APPROVED REFERENCE DESIGN

WASHINGTON PUBLIC POWER SUPPLY SYSTEM
 WPPSS NUCLEAR PROJECT NO. 3

SINGLELINE WIRING DIAGRAM
 HEATER CONTROLS

SHEET 1 OF 4

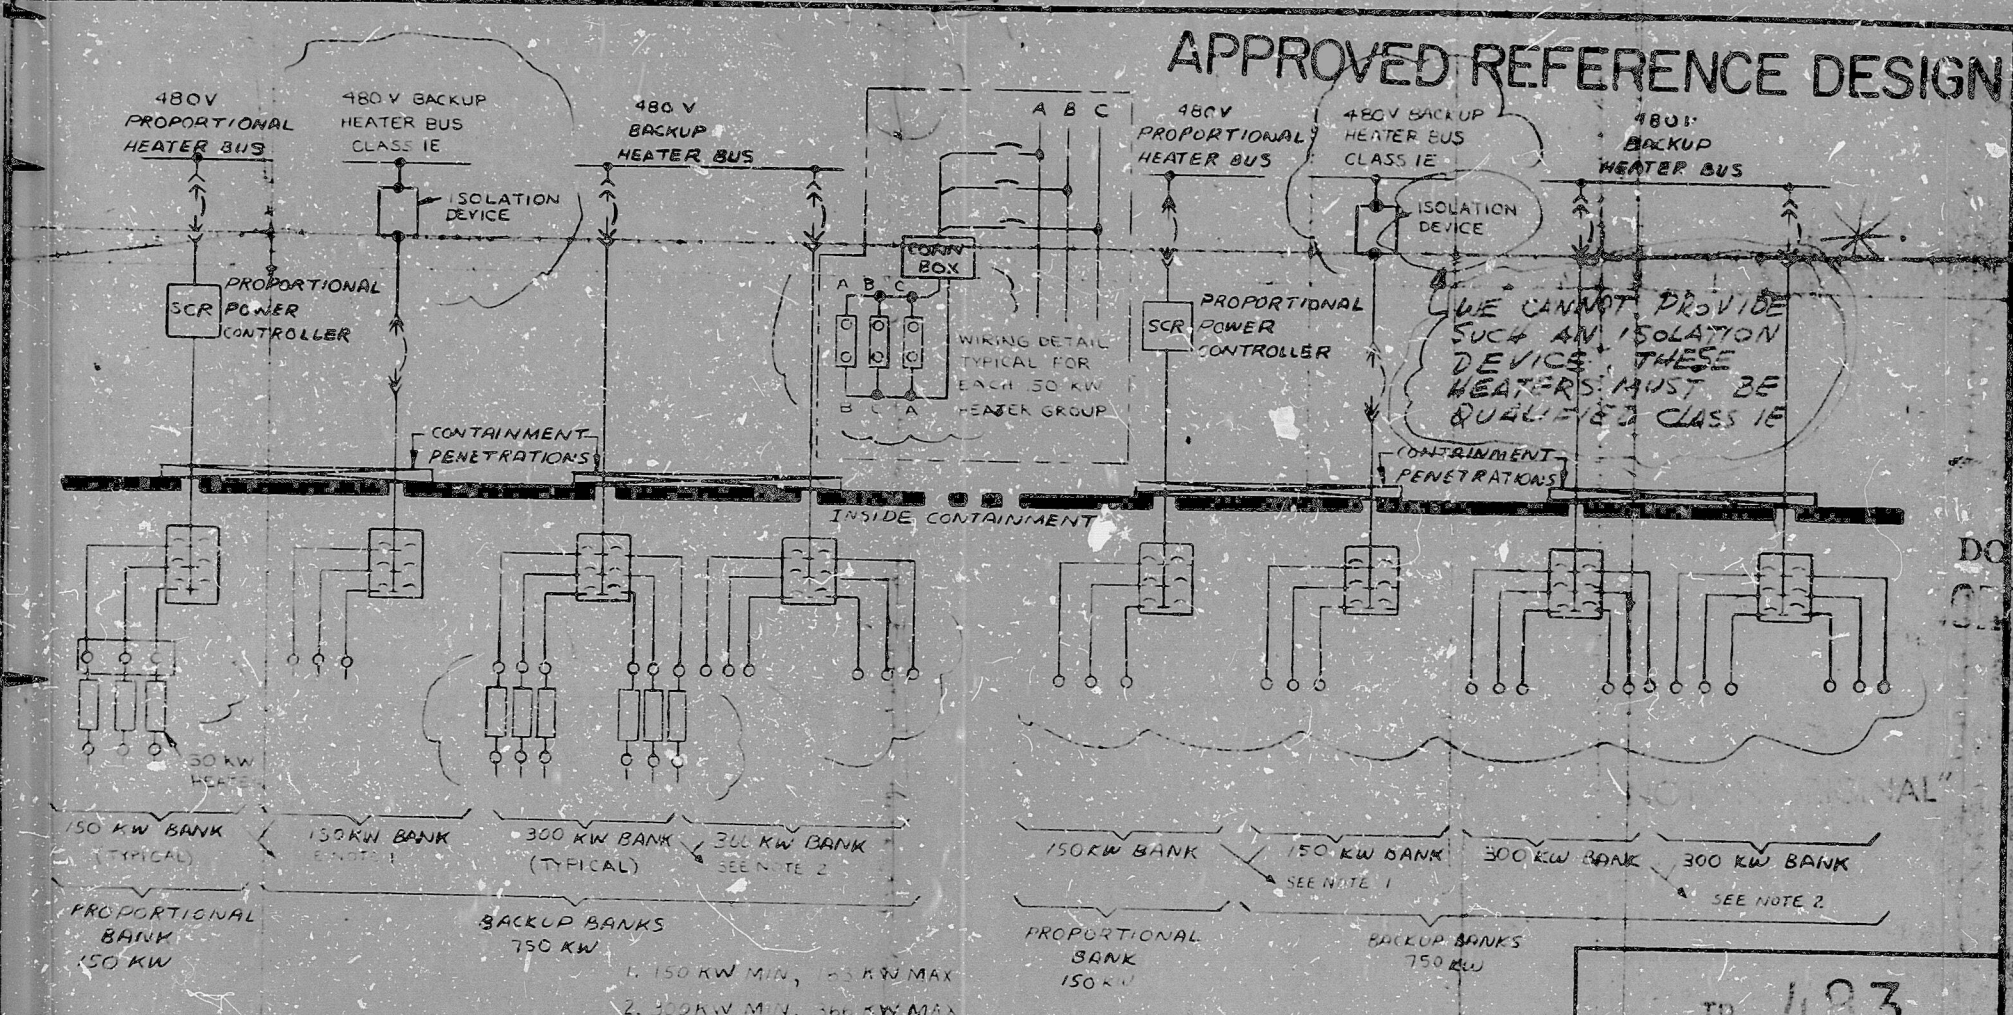
REV	DATE	BY	DESCRIPTION
1	1/22/77	W/C	FOR COMMENT REVISED LETTER CEEB-77-415
2	7/9/77	W/C	Comments by ELEC. DESIGN DODEG
3	7/17/77	W/C	Comments by ELEC. DESIGN DODEG
4	7/17/77	W/C	Comments by ELEC. DESIGN DODEG

REV	DESCRIPTION	BY & DATE	CHK & DATE	ENG. APPD	REV.	DESCRIPTION	BY & DATE	CHK & DATE	ENG. APPD	REV.	DESCRIPTION	BY & DATE	CHK & DATE	ENG. APPD	REV.
01	REVISED TO 4 WAS (OF 3) REVISED HEATER CONTROL AND RELATED CIRCUITS. UPDATED TO APPROVED DESIGN. REV. REV. 01-500-100
